ONS-2013-037

Subject: Duke Energy Carolinas, LLC
Oconee Nuclear Station, Units 1, 2, and 3
Docket Numbers 50-269, 50-270, and 50-287,
Renewed Operating Licenses DPR-38, DPR-47, and DPR-55
Licensing Basis for the Protected Service Water System - Responses to
Request for Additional Information Item Nos. 172 through 189
License Amendment Request (LAR) 2008-07 - Supplement 7

Supplemental Response to RAI 172 through 189
LAR 2008-07 - Supplement 7

Figure 1

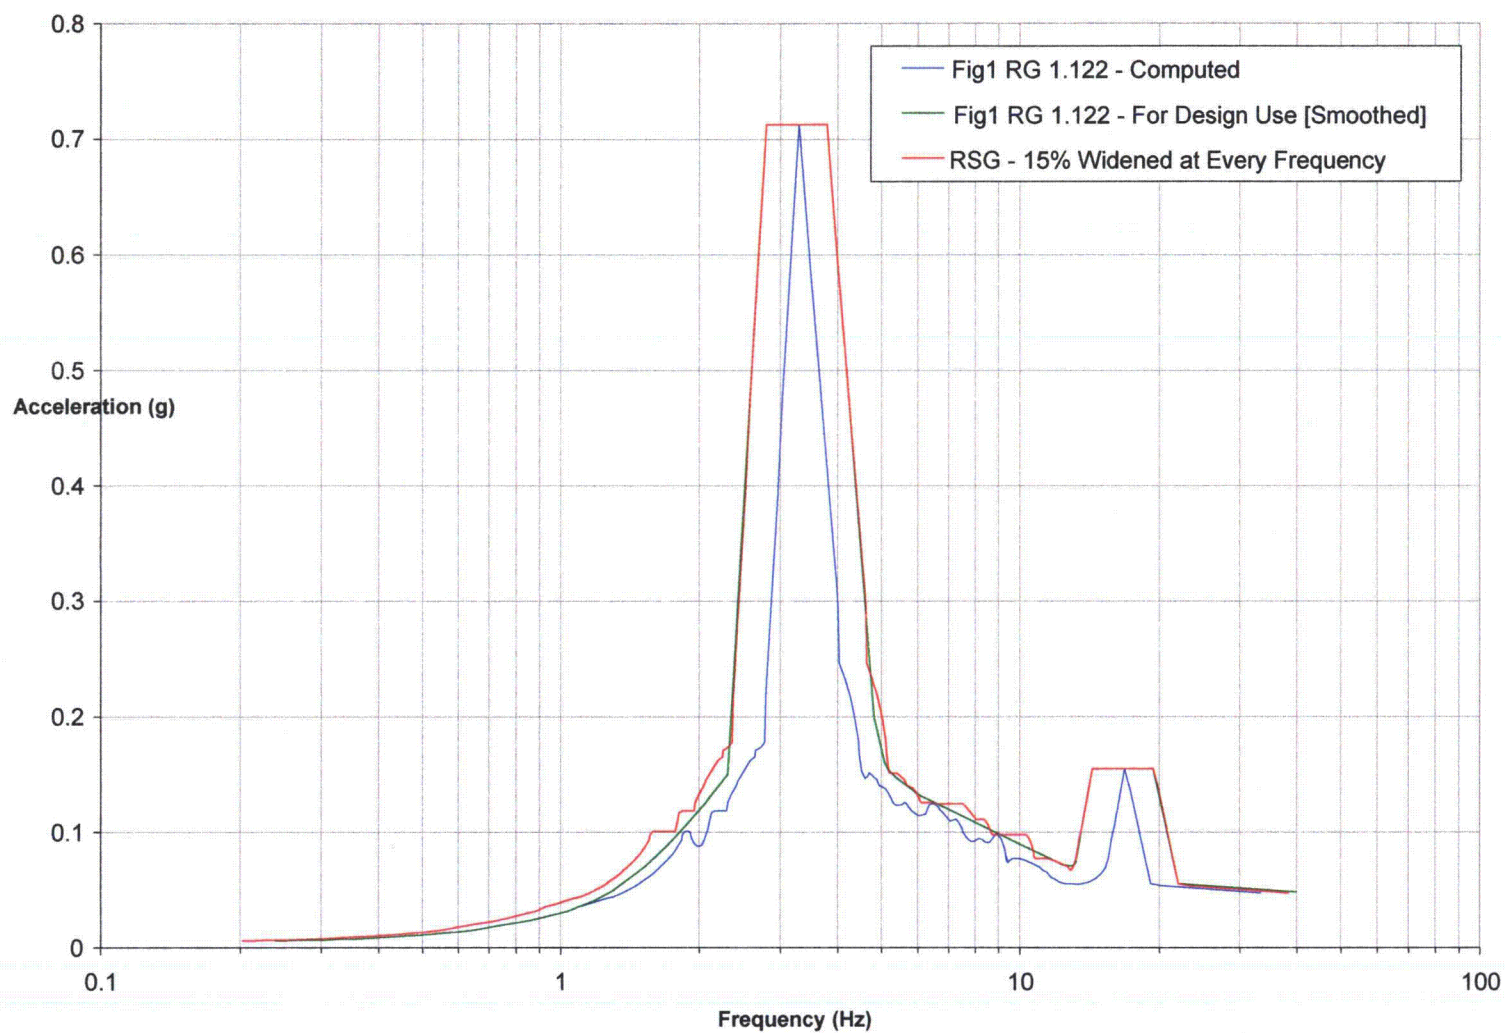
Licensee letter dated April 5, 2013, includes broadened in-structure response spectra (ISRS) for the PSW building. These ISRS exhibit sharp valleys and it does not appear they have been smoothed; thus, not satisfying the intent/guidance of Regulatory Guide 1.122. Discuss and provide further information relative to the effects of these non-smoothed ISRS on the design of the PSW components, subsystems and their anchorage.

Figure 1 provides a comparison of the widened response spectrum based on $\pm 15\%$ widening at every frequency for the example provided in Figure 1 of Regulatory Guide 1.122. As seen from this comparison, the widened response spectrum based on $\pm 15\%$ widening at every frequency bounds the smoothed response spectrum recommended for use by the RG 1.122 at almost all frequencies.

The $\pm 15\%$ widening at every frequency that was used for generation of PSW building response spectra is in accordance with the accepted industry practice and the resulting sharp valleys require no further adjustment. It is considered that widening the response spectra at every frequency, not just the peaks, eliminates the need for smoothing and is acceptable. This is evident from the NRC acceptance of similar response spectra with sharp valleys which are used for certified designs of Westinghouse AP1000 and GE ABWR. Figures 3 through 5 provide examples of the Westinghouse AP1000 response spectra [Reference ADAMS ML11171A440]. Figures 6 through 8 provide examples of the GE ABWR response spectra [Reference ADAMS ML11126A103]. Both examples exhibit response spectra with sharp valleys, that indicate the response curves were not smoothed.

FIGURE 9-45 PSW AC ELECTRICAL DISTRIBUTION

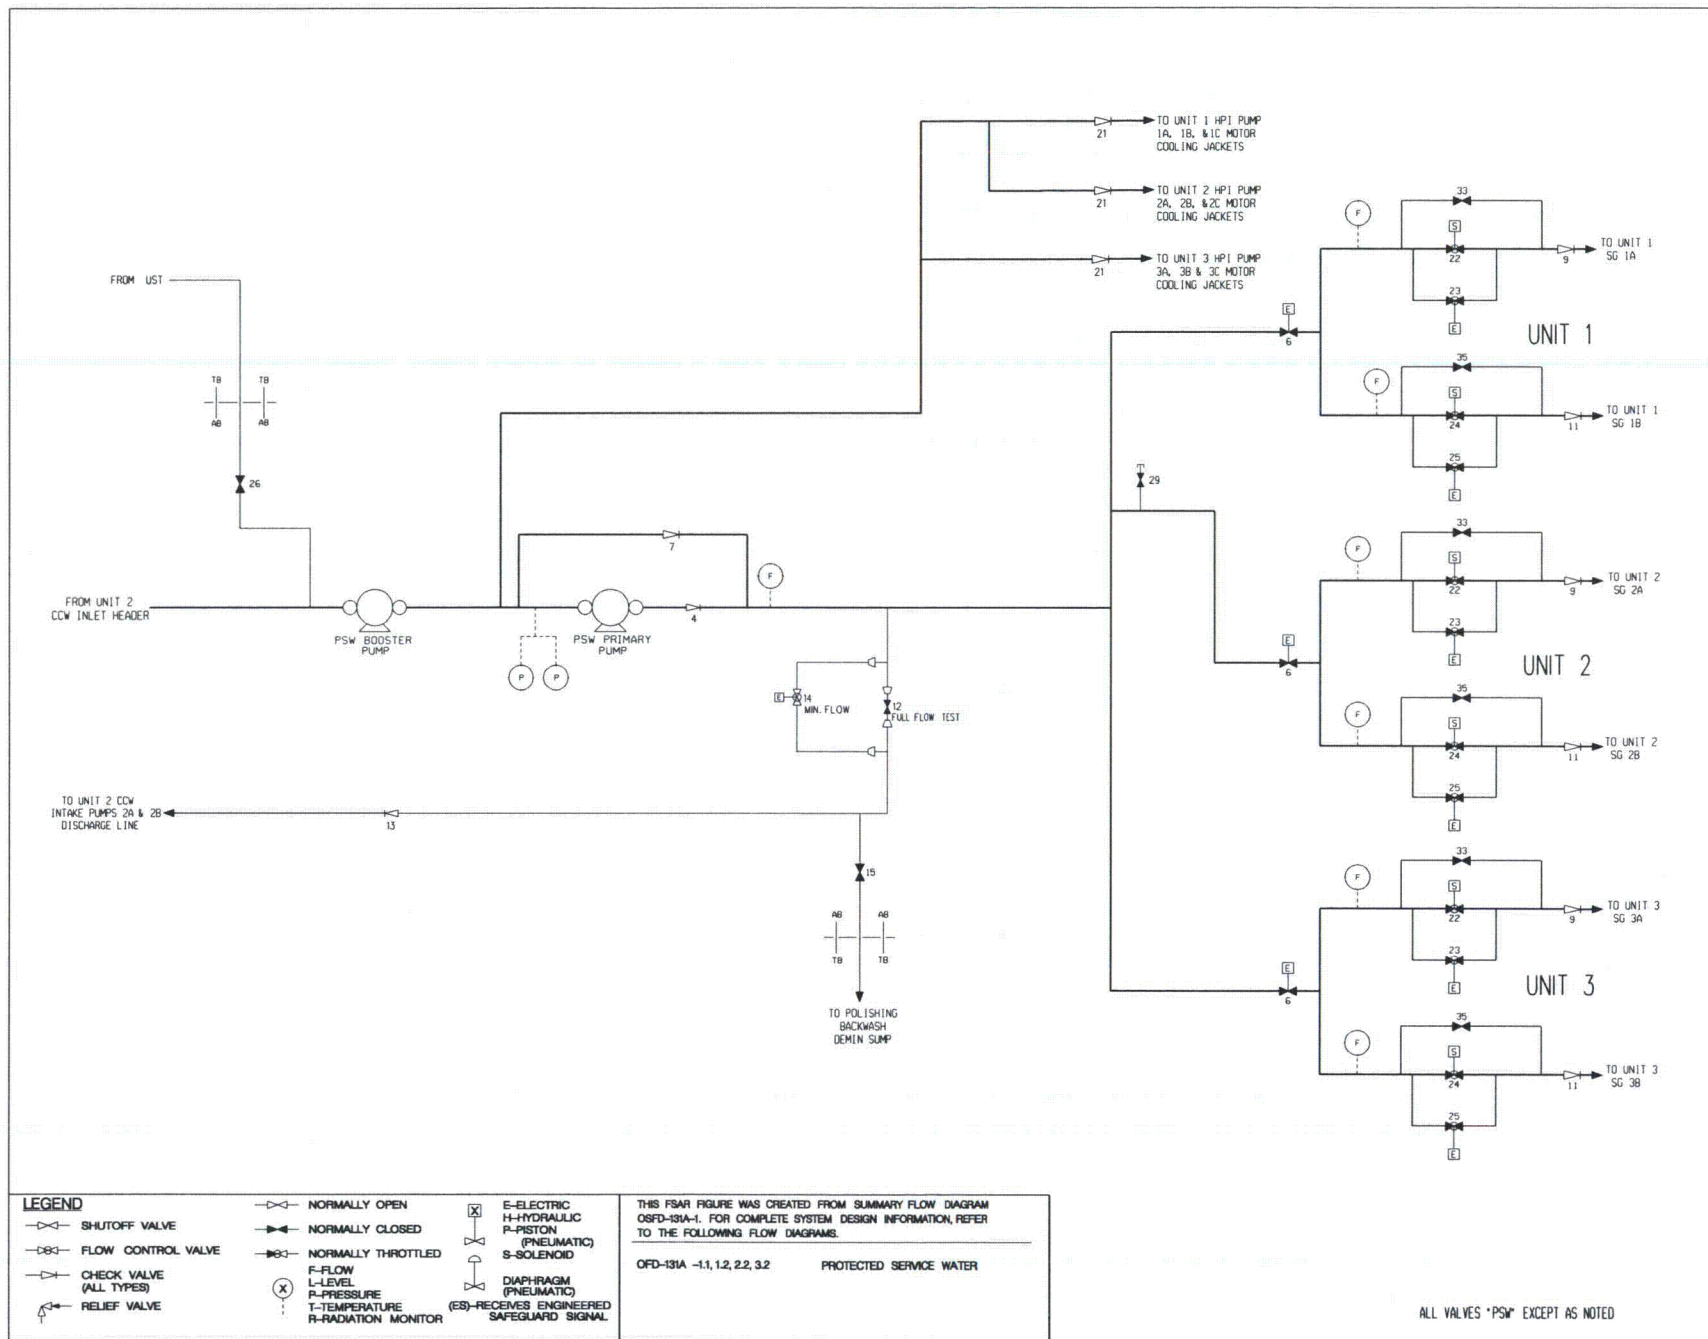
Provide a brief description including design ratings of all the electrical equipment that are part of the AWC system. Provide a summary of the analysis performed to conclude that electrical system for PSW and its support systems continue to provide adequate capacity and capability (voltage studies, short circuit studies, protective coordination, equipment and bus loadings, etc.) needed to establish and maintain a safe shutdown condition for postulated events. Also describe if adequate margins remain on the PSW electrical system. If revision is necessary to include the AWC system, provide updated figures which were included in the licensee letter dated August 7, 2013, (Figure 9-45, PSW AC Electrical Distribution and Figure 9-46, PSW DC Electrical Distribution).

Updated figure 9-45 in the Duke Energy letter dated August 7, 2013

Figure 9-45 "PSW AC Electrical Distribution" is revised to reflect the addition of feeding the AWC AC Electrical Distribution System and is included in Attachment 2.
